Supplementary Information from AAHK on 3RS EIA Report to ACE EIASC Secretariat

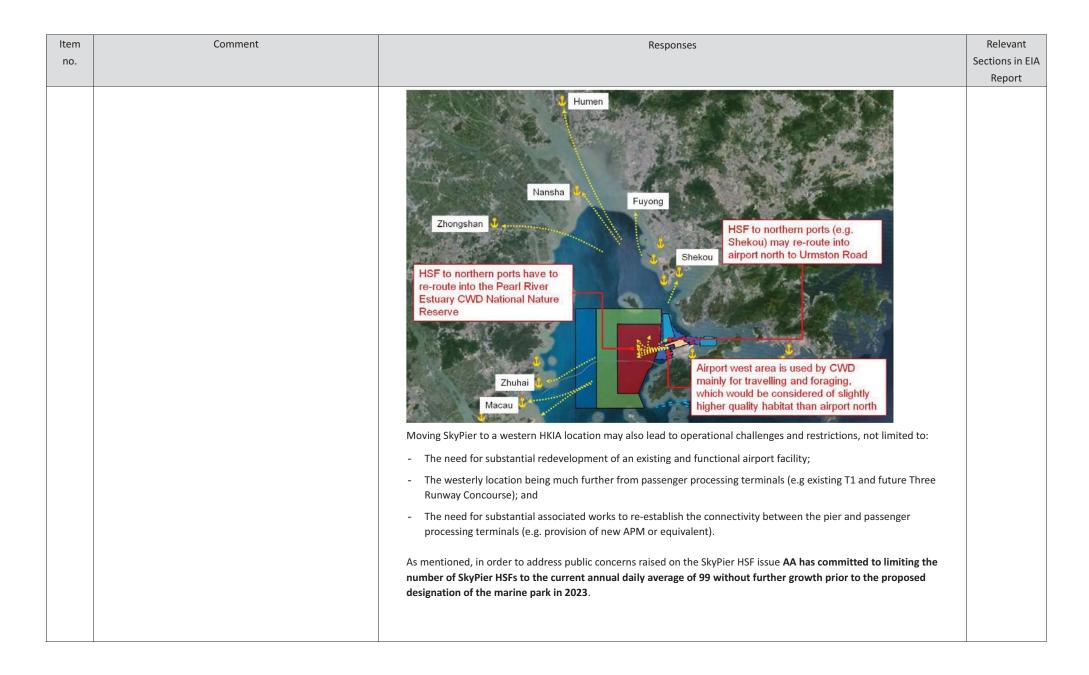
1.	Impact assessment on CWD over the proposed speed limit and route diversion of SkyPier HSF, i.e. reduction of speed limit vs congestion of vessels and increase in traffic duration in the Sha Chau and Lung Kwu Chau waters	A range of literature has been reviewed on risks to dolphins from vessels travelling at speed and potential impact from vessel noise and in addition recent dedicated studies in Hong Kong investigating these aspects have been considered. Of all the vessel traffic anticipated to be using the area of open waters between HKIA and the SCLKCMP (this area of water expected to be further narrowed / constrained during 3RS construction), HSF traffic poses the most significant risk to dolphins in terms of both physical risks from collision and disturbance from underwater noise. AAHK therefore recommended that SkyPier HSFs using this stretch of open waters between HKIA and the SCLKCMP travelling to and from Macau / Zhuhai should be diverted to the north of SCLKCMP and at the same time be subject to a 15 knots speed limit through areas with relatively high CWD density, as illustrated in the diagram below.	13.9.2.91 to 13.9.2.112, and 13.11.5.12 to 13.11.5.13 , Appendix 13.13 (e.g. section 12.8)

Item	Comment	Responses	Relevant Sections in EIA
no.			Report
		START OF CONSTRUCTION TO DESIGNATION OF MARINE PARK The EIA determined that this proposed mitigation measure for SkyPier HSFs - route diversion and speed restriction - is	
		expected to reduce HSF impacts on CWDs as the SkyPier HSFs represent about 60% of all HSFs travelling across the area of open waters between HKIA and the SCLKCMP. Re-routing this traffic reduces the physical threat and underwater noise impact from fast-moving HSFs on CWDs in the area of open waters between North Lantau and the SCLKCMP.	
		The assessment has also considered that re-routed HSFs will in turn pass through waters of known higher CWD abundance than in the open water area north of HKIA. However, the proposed 15 knot HSF speed limit as proposed for the part HSF journey across higher CWD abundant areas is expected to reduce impacts from the diverted HSFs to acceptable levels in these areas. In making this assessment, it was noted that it is the speed of vessels, as compared to the volume of traffic that is a fundamental factor for risk/ disturbance to CWDs. It is noted in the literature that a 10 knot vessel speed limit is an optimum criterion to mitigate against vessels hitting dolphins and that sounds produced by vessels travelling at 10 knots are of lower frequency and also tend to fall outside the frequency range of major CWD communication/ echolocation. However, the risk of vessel / dolphin collision and the reduction in noise from an HSF travelling at 15 knots rather than at 30-40 knots is considered to result in a considerable reduction of risk to a level that is acceptable to CWDs from the diverted HSFs.	13.11.5.4 to 13.11.5.13
